MINING IMPACT SPECIALISTS LTD. <small>ENABLING CHANGE TO SERVE FUTURE GENERATIONS.</small>	 <small>EST. 1971 LIMITED environmental research associates</small>	2023 Mary River Project Site Visit #2		
		Key Photos from September 2023 Inspection		
Mining Impact Specialists Ltd.	LGL Limited	Date: 05 Dec 2023	Approved: LEB	Page: 17

RESPONSE TO QIA September 2023 General Site Inspection Findings and Recommendations

To:	Jim Patterson	Date:	February 6, 2024
c:	Baruck Wile, Rudolf Dietrich, Emmanuel Ocran, Abid Najey	Memo No.:	
From:	Charlie Harrison	File:	704-ENG.EARC03209-10
Subject:	Revised the Issued for Construction (IFC) Drawings for the KM105 Sedimentation Pond Grout Curtain

The Qikiqtani Inuit Association (QIA) contracted M.A. O' Kane Consultants Inc. (Okane) to complete the 2023 Environmental Audit (Audit) of the Mary River Project (Project), operated by Baffinland Iron Mines Corporation (Baffinland). This Audit was completed in accordance with Schedule D and E of the Commercial Lease No.: Q13C301¹ (Lease). The focus of the Audit was to verify the adequacy of environmental security provided by Baffinland pursuant to the Lease.

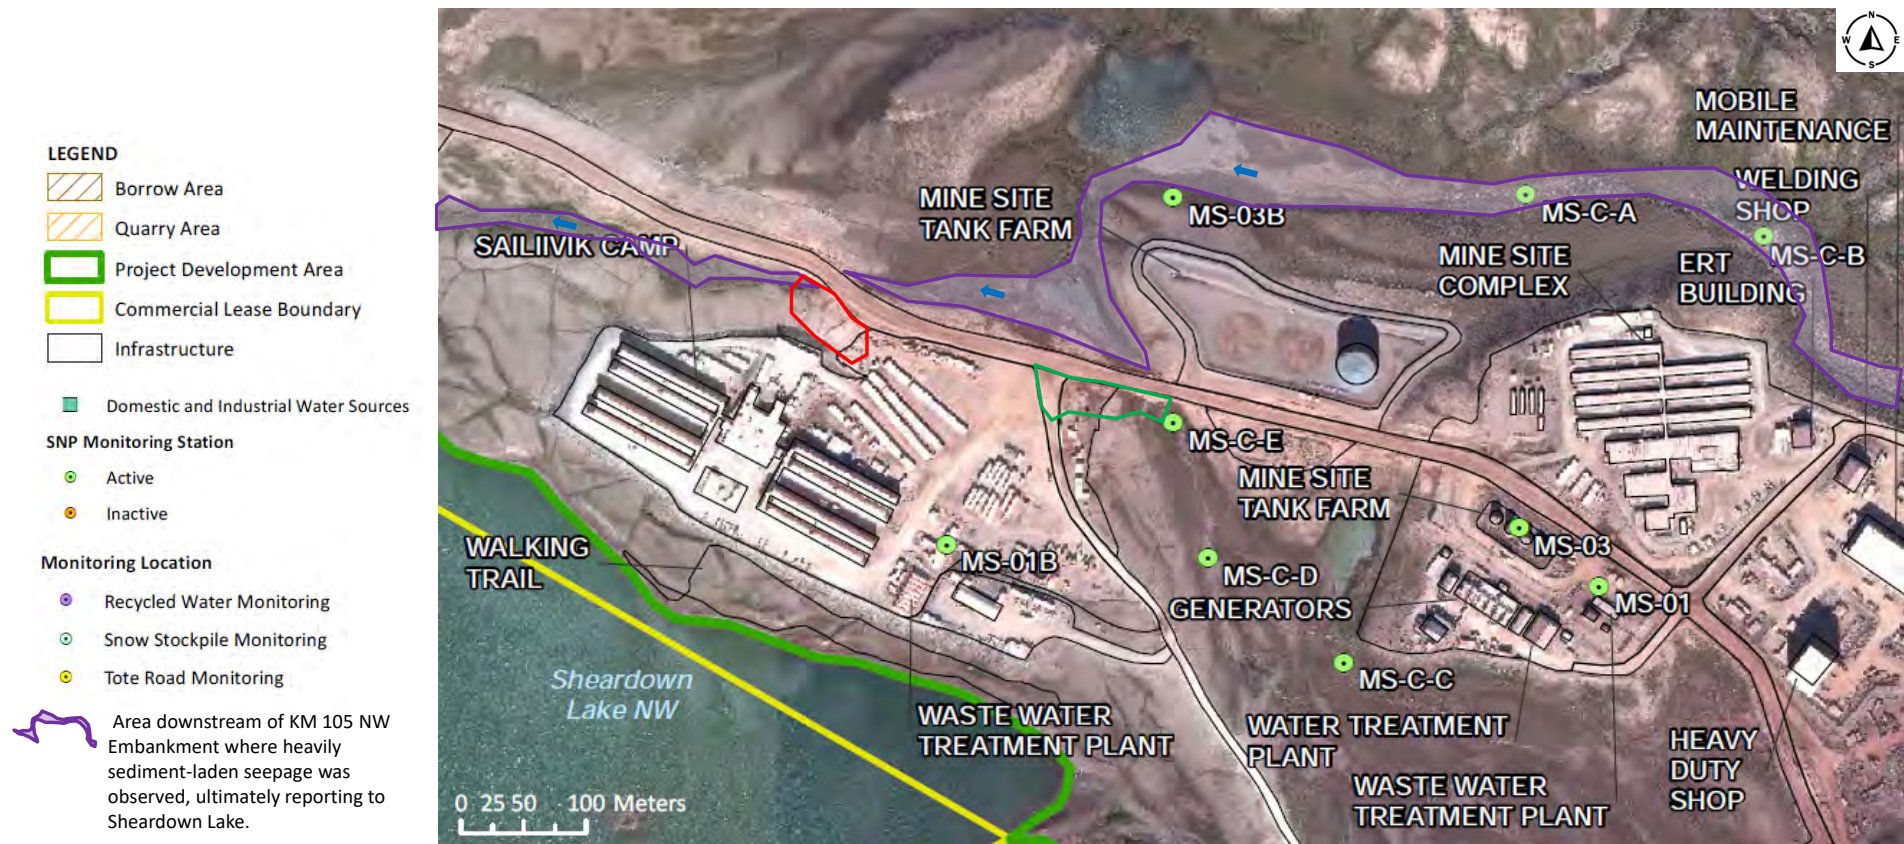
Area downstream of KM 105 NW Embankment that functioned as a secondary sedimentation pond during 2023 Freshet.

WORK AREA LAYOUT PLAN VIEW

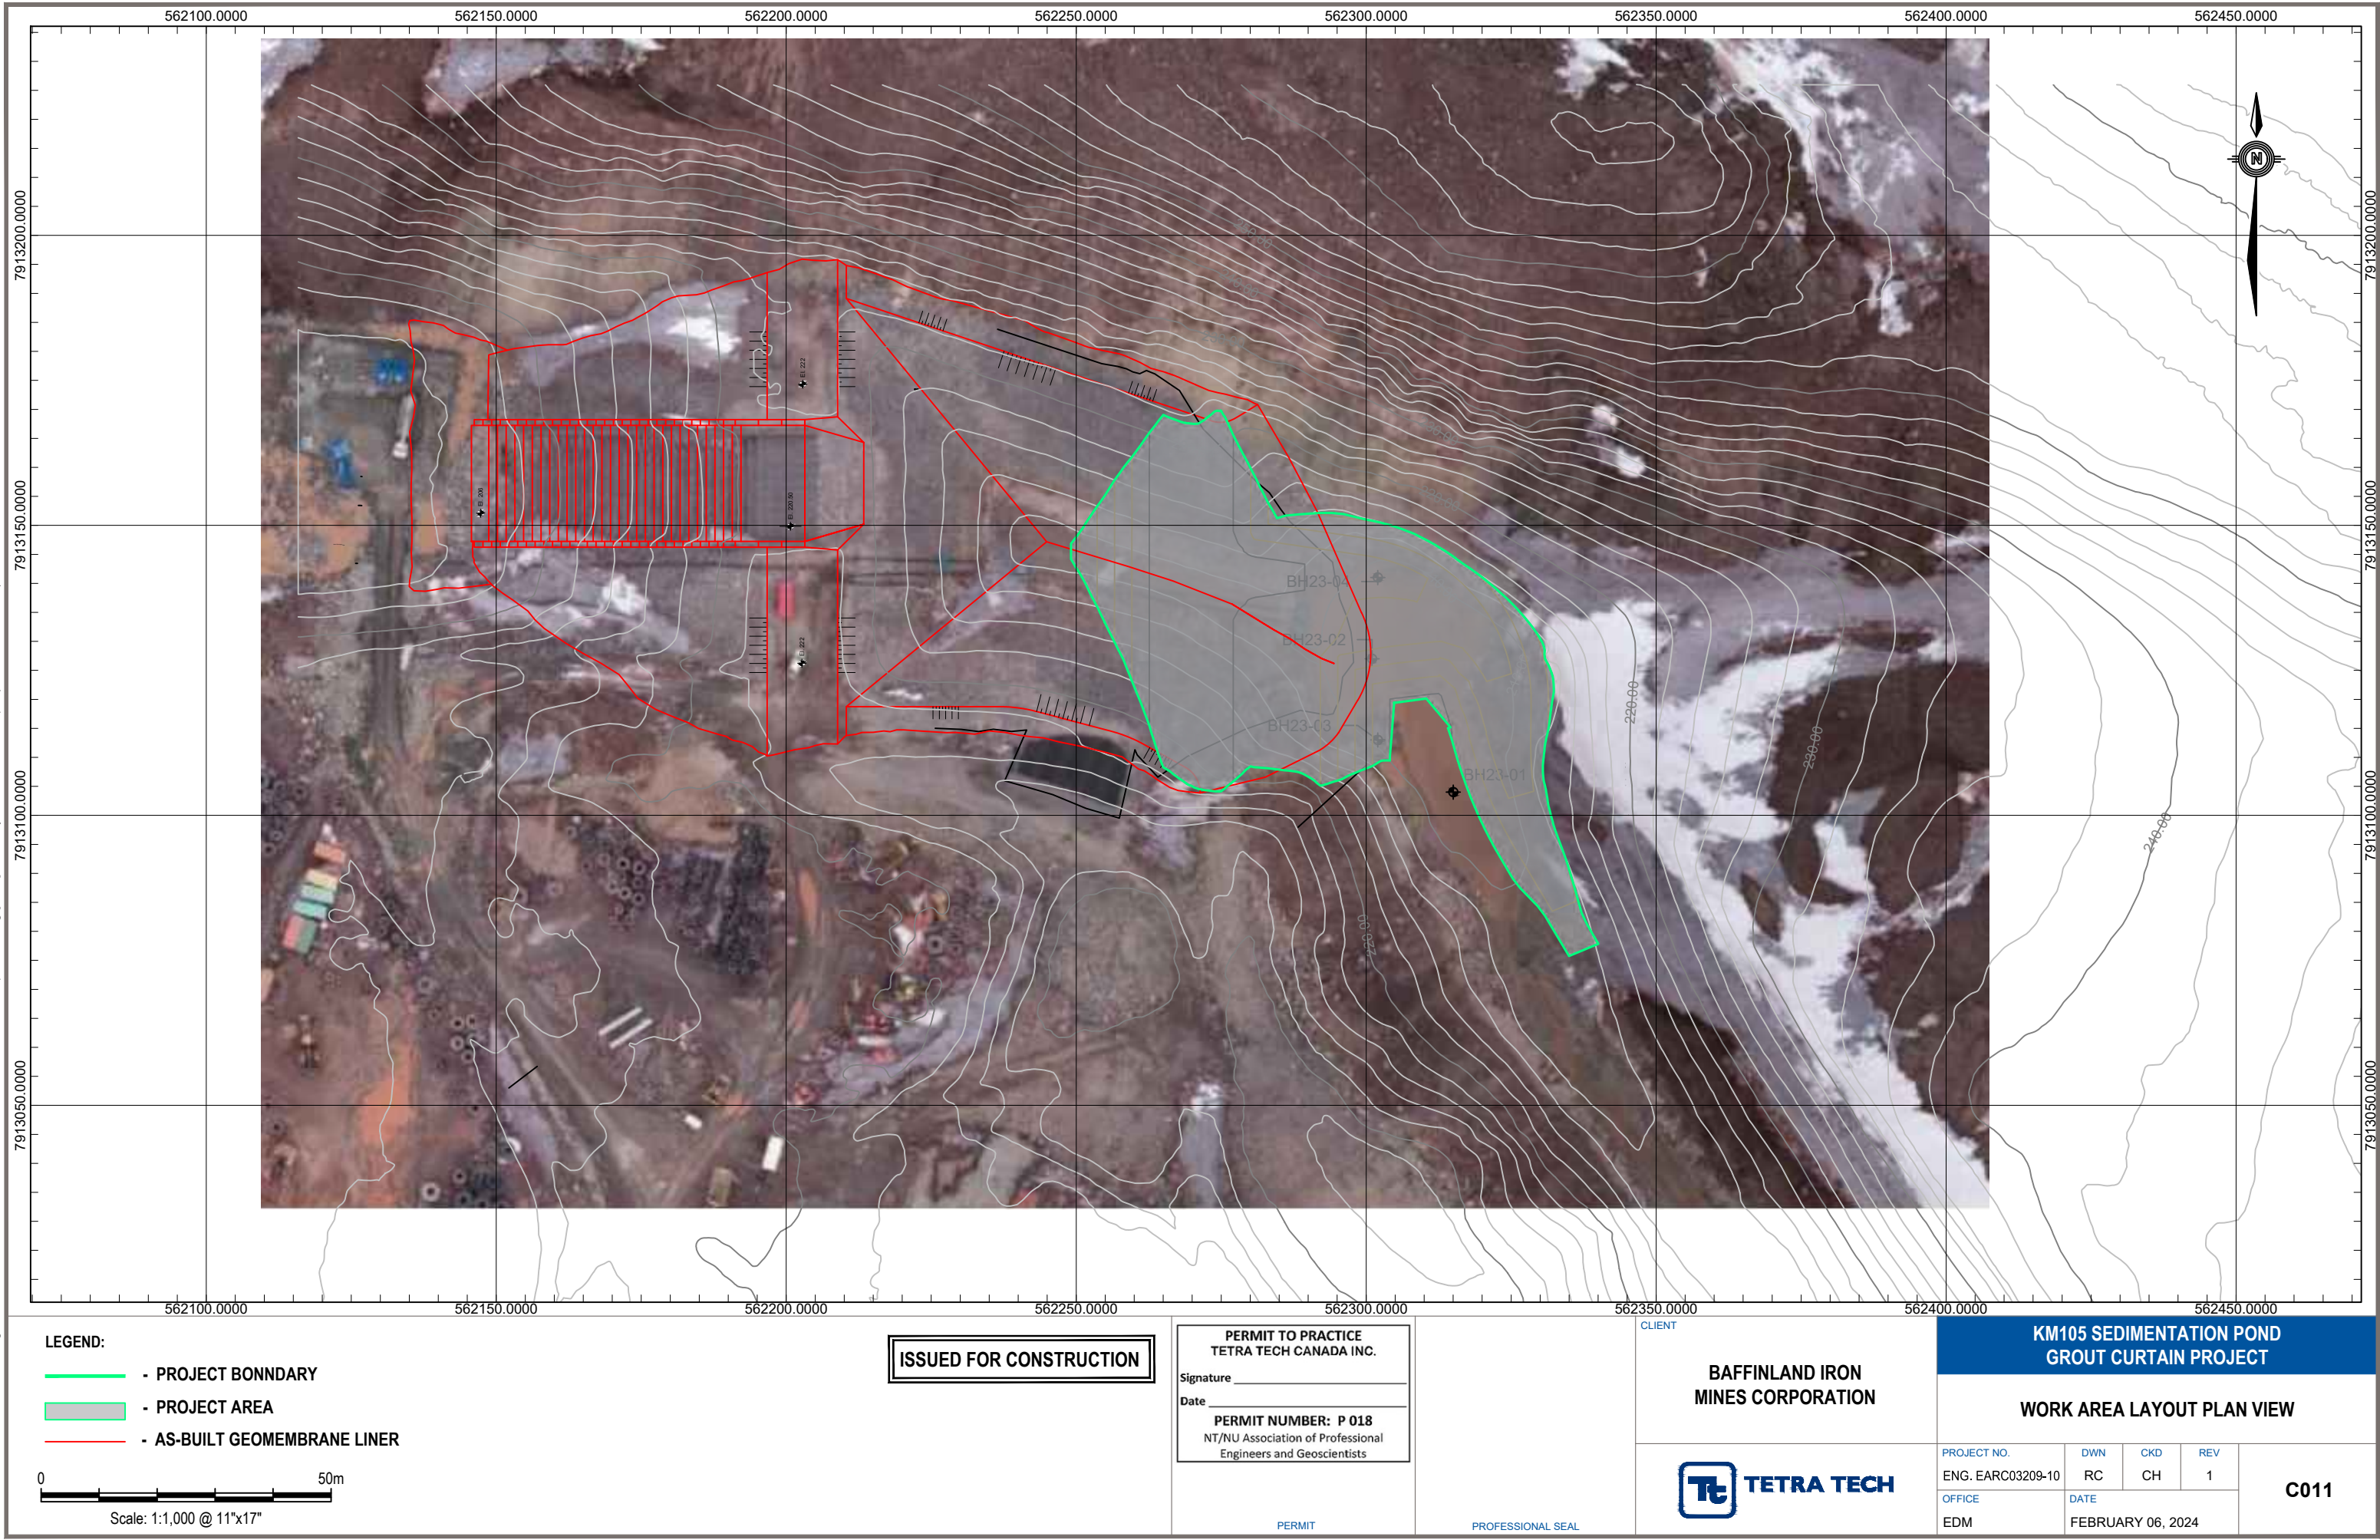
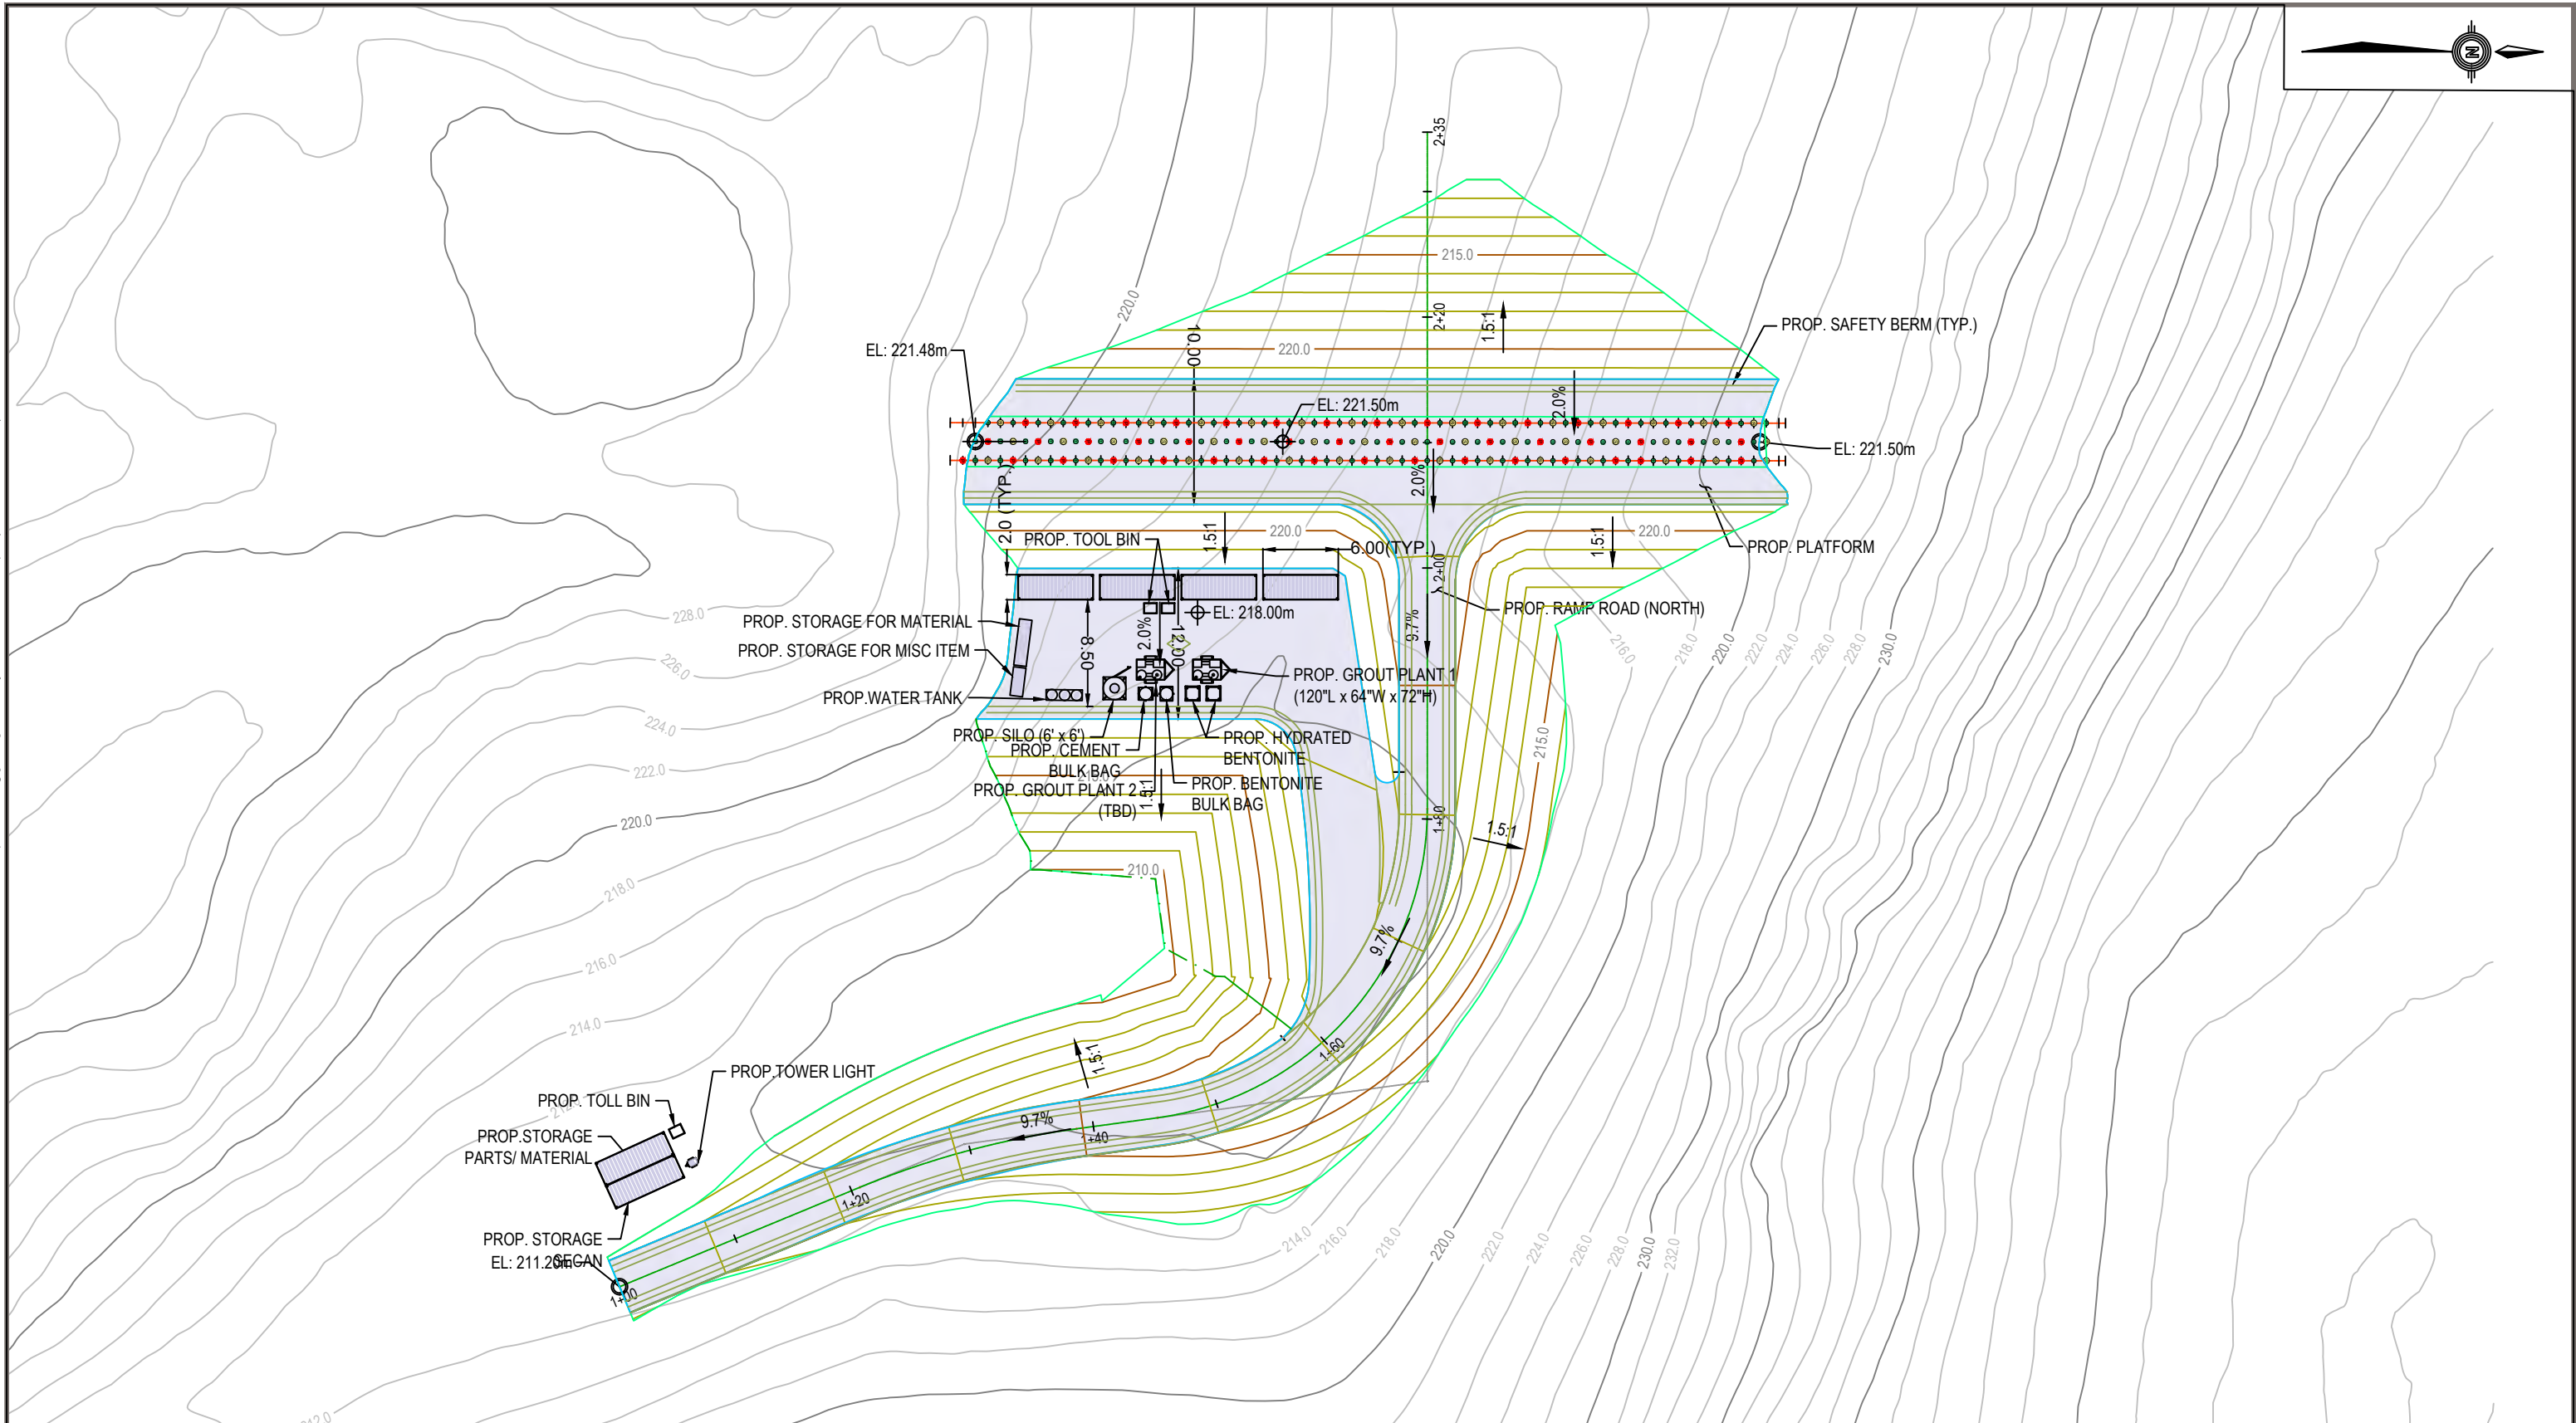
1. Revised alignment for the grout curtain: the grout curtain was shifted to the east by about 25 m to allow for the grout holes to be advanced through the existing geomembrane liner. This will accommodate a direct connection between the top of the grout curtain and the existing liner system for the pond.
2. Revised alignment of the temporary platform: the temporary platform was realigned to match the revised alignment of the grout curtain.
3. Temporary platform fill material: the central core material was changed to 19 mm minus crushed sand and gravel from 50 mm crushed sand and gravel to accommodate the change in drilling methodology, as recommended by Keller.
